**ADDENDUM # 3
TO THE CONSTRUCTION DOCUMENTS
For
Lumber River State Park – Wire Pasture Access Development
SCO ID # 16-14432-01A
for the
Division of Parks and Recreation**

Date: July 25, 2024

The following changes, additions, and/or deletions are hereby made a part of the Construction Documents for the above noted project, fully and completely as if the same were fully contained therein. All other terms, conditions, drawings and specifications of the Construction Documents remain unchanged.

OVERALL SITE PLAN

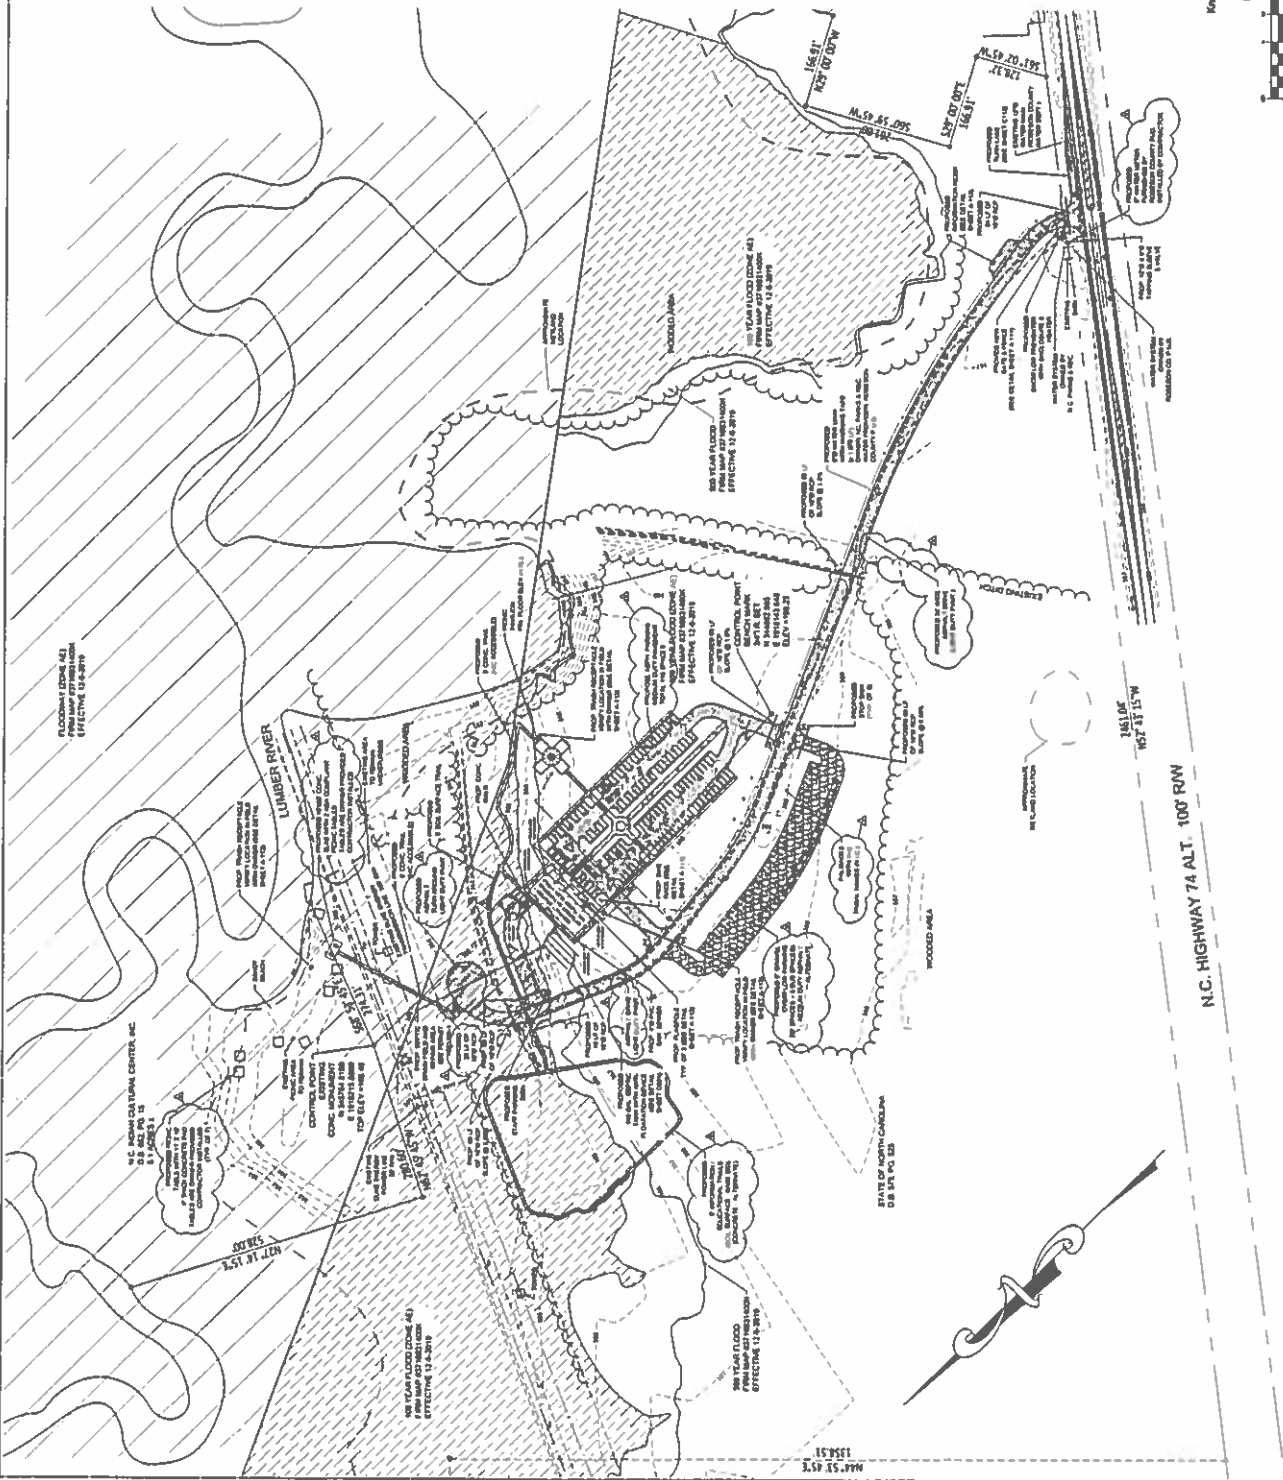
7. Drawing C102: Drawing C102 description calls for H/C Parking Sign (Typ. of 10), whereas plan view shows a total of 9 H/C parking signs. Please clarify which one is to be considered.

Answer – Provide 9 H/C signs. See revised sheet C102.

DATE DATE: 6-16-2020
DRAWN BY: [Name]
CHECKED BY: [Name]
PROJECT NO.: 16-14432-01A
SHEET NO.: 101
TOTAL SHEETS: 101
SCALE: AS SHOWN
PROJECT LOCATION: [Address]
CLIENT: [Name]
DESIGNER: [Name]
APPROVED BY: [Name]
DATE OF APPROVAL: [Date]

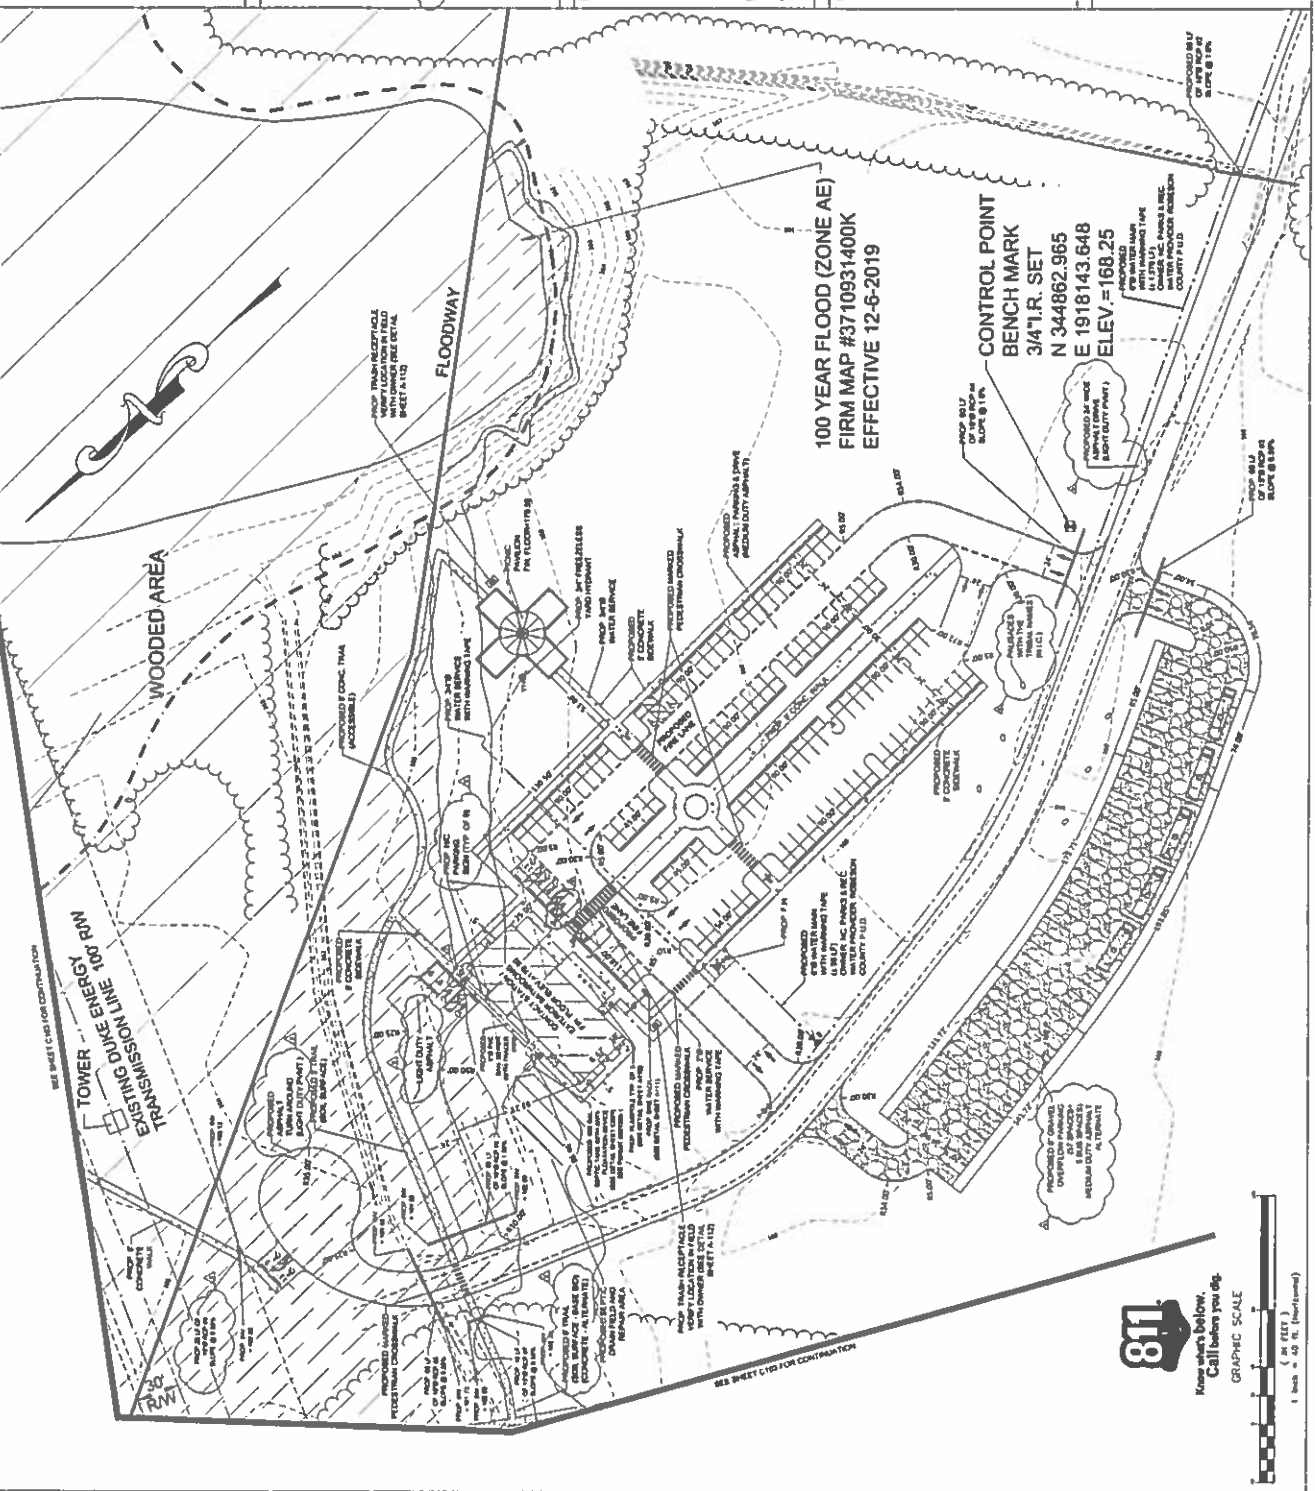
1. Drawing C101 shows "Proposed 5' Information/Educational trails (Soil Surface) Alternate" westside of the roadway and Proposal Form calls "Alternate No. G-2 – Provide the Concrete Information/Education Trail. Does this mean construction of Soil Surface is part of Base Bid and construction of concrete trail in lieu of soil surface is Alternate G-2?"

4. Drawing C101: Drawing calls for 6" water meter to be furnished by the Robeson County Public Works Department. Please advise if this water meter is to be "Furnished and Installed" by Robeson County and "all associated meter fees including and utilities capital fees if any" for obtaining the meter are to be paid by Owner. Capital facility fees are typically substantial.

8. Drawing C101: Please confirm the quantity of scattered picnic tables and quantity of ADA compliant picnic tables.

12. Drawing C101 & A –111: There is no elevation or description of fence provided approximately 30 feet either side.

Answer – Soil surface is part of base bid and concrete trail in lieu of soil surface trail is Alternate G-2. See revised drawing C101.

Answer – Meter will be furnished by Robeson County Water System, Installed by Contractor, Inspected by Robeson County Water System. See Revised sheets C101 & C621.

Answer – Provide 7 picnic tables at scattered sites and 2 ADA Tables with concrete pads 4" thick. Tables to be owner provided contractor installed. See Revised sheet C101.

Answer – Palisades are Not In Contract. See revised sheet C101.

Answer – Pipe revised to 15" RCP. See revised Sheet C101.

C601

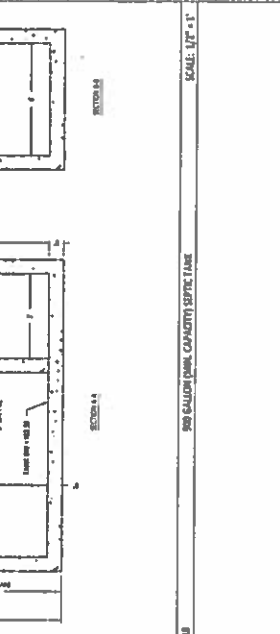
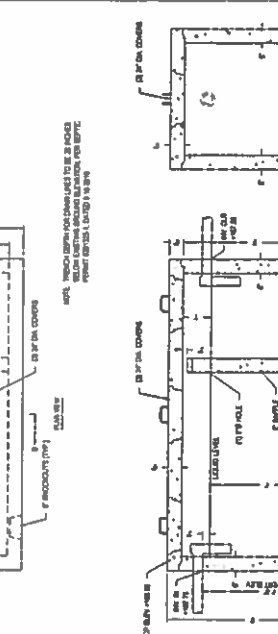
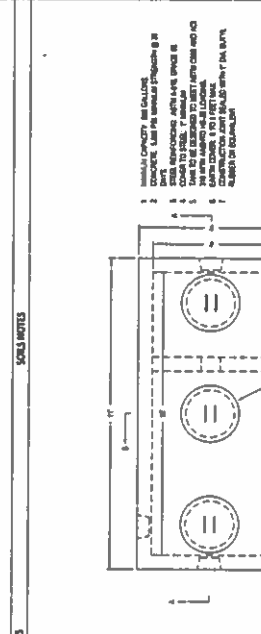
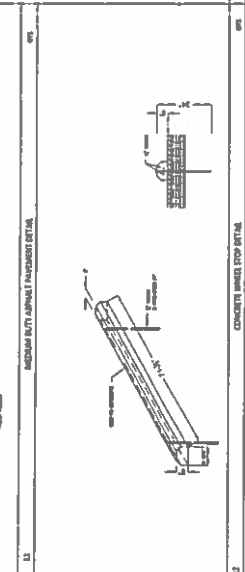
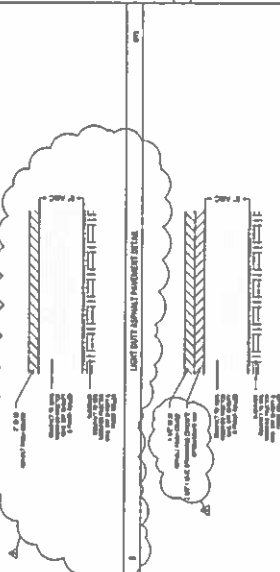
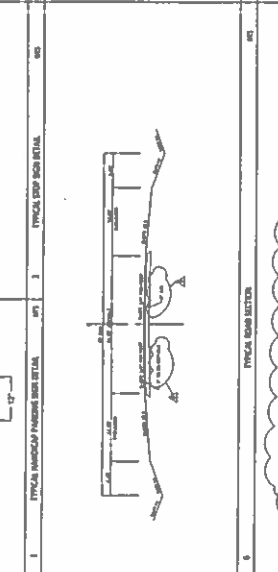
5. Drawing C101: There is no construction detail shown for the proposed septic drain field and repair area. In addition, drawing to see Permit #281325-1 for the septic drain field and septic tank. Can the permit documents with the construction details be provided?

56. **Drawing C601:** on plan sheet C601, for the Typical Road Section, the asphalt material spelled out is a type I-2. This is an old type of mix and no longer used by NCDOT. Can this be replaced by with a S9.5B type surface course mix to match the rest of the site paving.

57. **Drawing C601:** On plan sheet C601, the Medium Duty asphalt Pavement Detail shows a 2" I19.0B binder mix and 1.5" SF9.5A surface course. Can the binder mix be changed to I19.0C since there is no I19.0B and can the surface course be changed to S9.5B to match the rest of the site paving since SF9.5A is no longer a viable mix type?

58. **Drawing C601:** Also concerning the I19.0C mix to be used for the Medium Duty Asphalt Pavement, according to NCDOT 2024 QMS Specifications this mix type should be placed a minimum 2.5" thickness because of the make-up of the materials. Can this be changed to meet NCDOT requirements and specifications since we will be held to those specifications?

Answer – Refer to Revised Sheet C601 for septic tank detail. Septic Tank Permit is attached.

Answer – See the attached revised Sheet C601.

Answer – See attached revised Sheet C601.

Answer – See the attached revised Sheet C601.

LANDSCAPING PLAN
DATE: 08/20/2014
SHEET NO. 1 OF 1

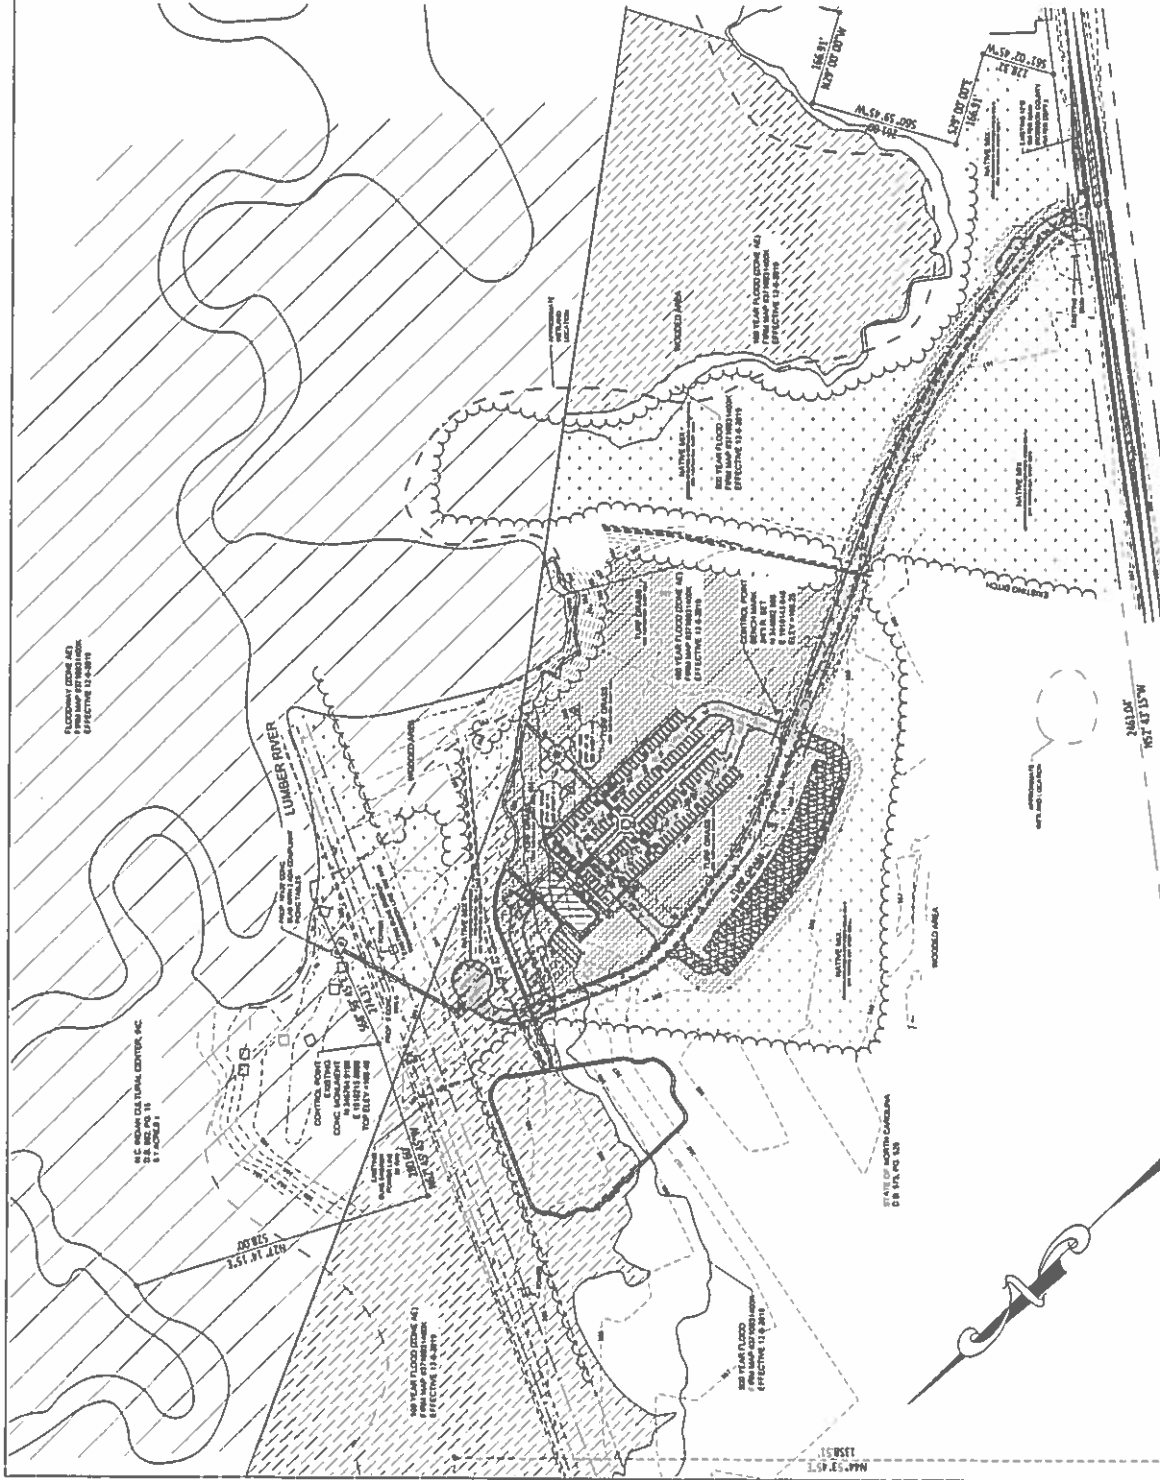
13. Drawing L101: Drawing L101 calls for 11 shrubs/16 trees and references sheet L100 that does not exist.

63. **Drawing L101:** On the landscape plan sheet, L101 there are 16 trees and 11 shrubs shown but no further information. Are these to be included in the base bid and if so, what size, type and installation method should be used.

Answer – Reference to sheet L100 have been revised to indicate A-113 for the shrub/trees details and information. See Revised Sheet L101.

Answer – Revised Sheet L101 to refer to Sheet A-113.

A - 103
SHEET OF

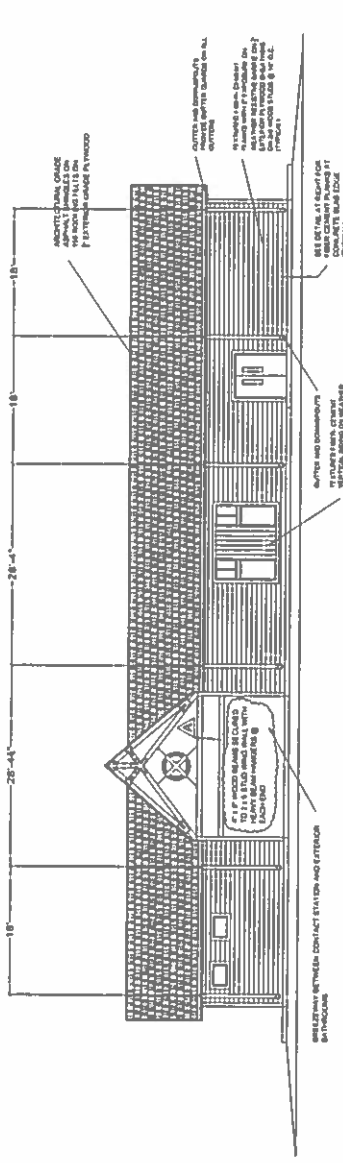
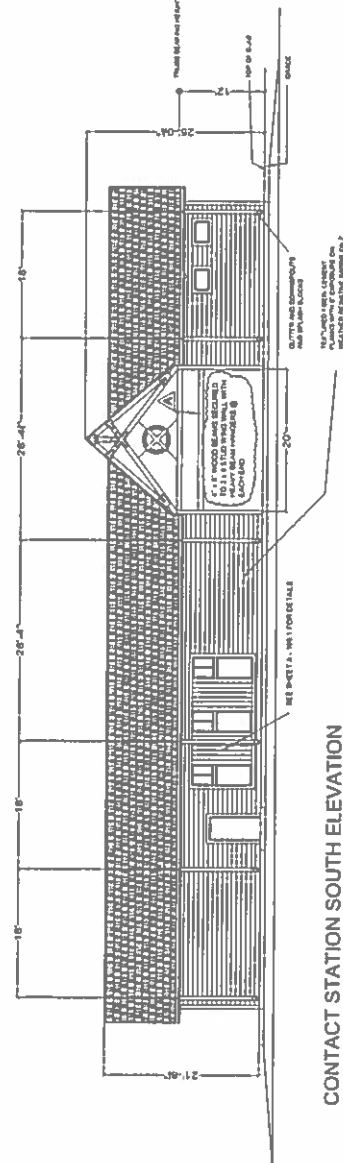
16. Drawing A – 103: Contact Station north and south elevation in drawing A -103 there appears to be beams under the scissors truss please advise.

Answer - Those beams are 4" x 8" supported by the exterior wall with beam hangers. See note on attached revised sheet A – 103.

LAVATORY

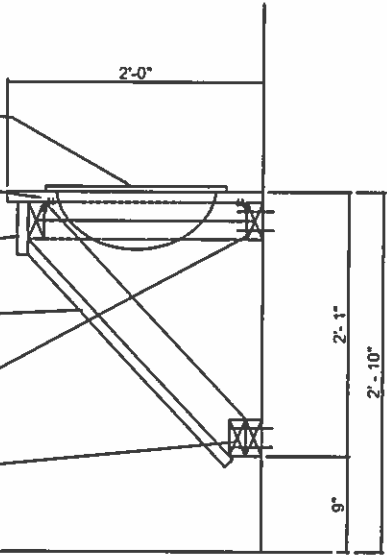
- Answer - Refer to the attached Bulletin Drawing BD001 for the Dressing Area Seat Detail.
23. Drawing A – 101 & A – 106: There is no material /section detail for lavatory counter.

- Answer - Refer to the attached Bulletin Drawing BD002 for material & section detail for the lavatories in the bathrooms.
24. See Specification Section of this Addendum.

X4.03
SHEET OF

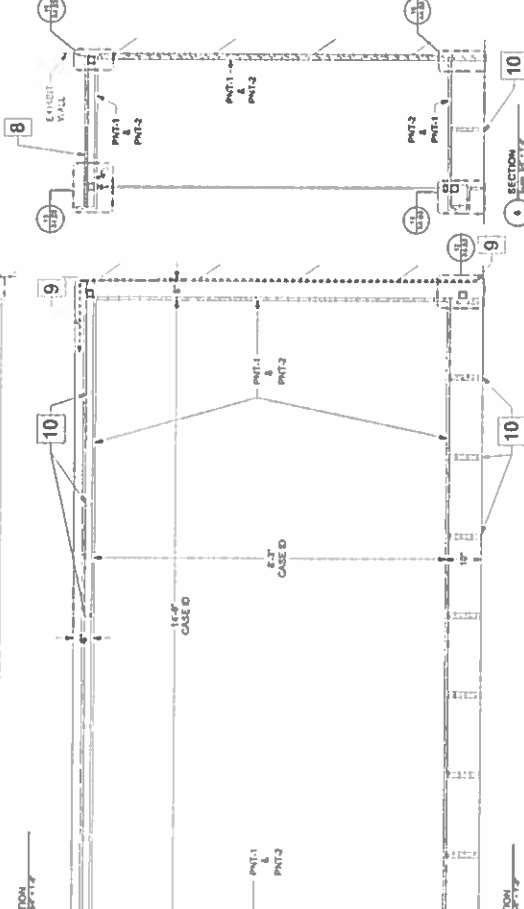
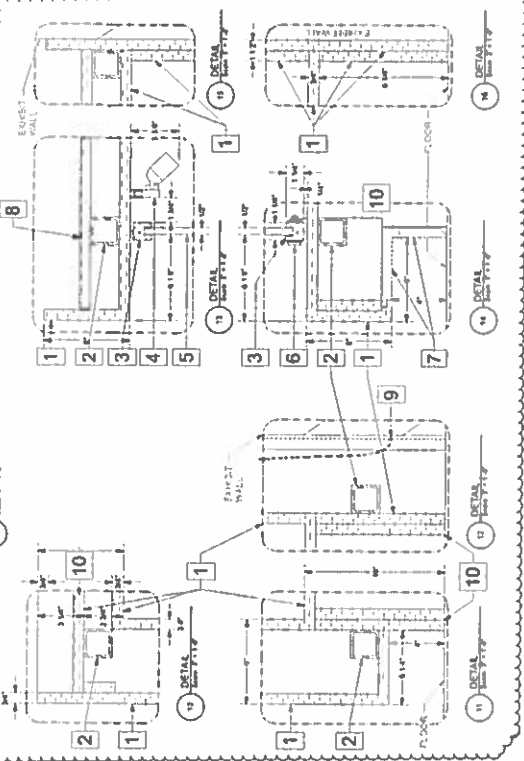
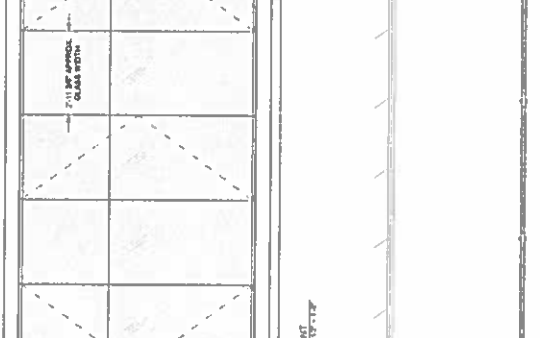
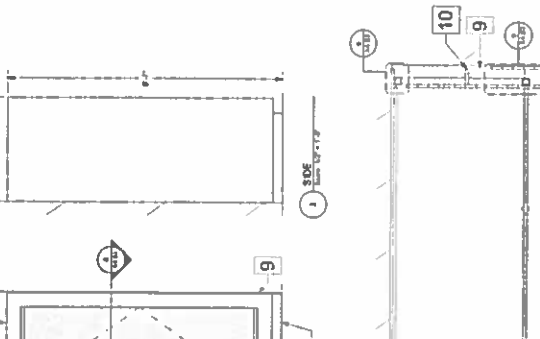
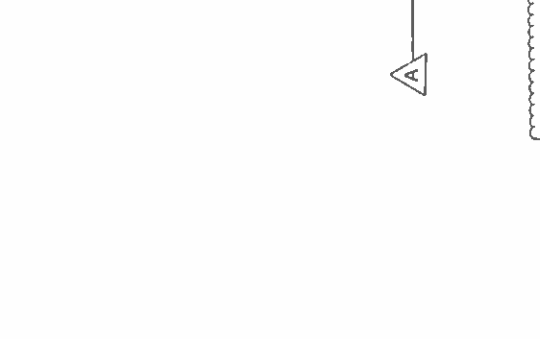
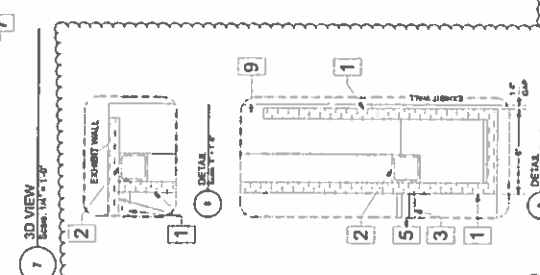
30. **Drawing X4.03: Gasketing Requirements for Exhibit Display Case doors.**
Answer – Gasketing is not required on Exhibit Display Case doors vertical seems.

31. **Drawing X4.03: Drawing X4.03 specifies the use of ½” low-iron glass. Please clarify if Exhibit Fabricator should offer laminated or tempered safety glass?**

Answer – Exhibit Display Case does not require independent humidity control.
33. **See Specification Section of this Addendum.**
34. **Drawing X4.03: Drawing X4.03 appears to be missing design information in several detail notes including 8,9,13,14,15 &16.**

51. **Case Lighting:** Is the Exhibit Fabricator supposed to provide & install the Luxam H-Track & (10) Fixtures referenced for use in Key Notes #9 on Drawing X4.03?

Answer – Provide ½” laminated glass.
32. **Drawing X4.03: Please confirm that the large Exhibit Display Case shown on Drawing X4.03 is not sealed against room air exchange and does not require built-in humidity control.**

Answer – See the attached Revised Sheet X4.03.
35. **Exhibit Graphics: Is Digital scanning required, if so is there an estimate of how many scans will be needed.**

Answer – Yes, the Exhibit Fabricator is supposed to provide and install the Luxam H-Track & 10 fixtures.
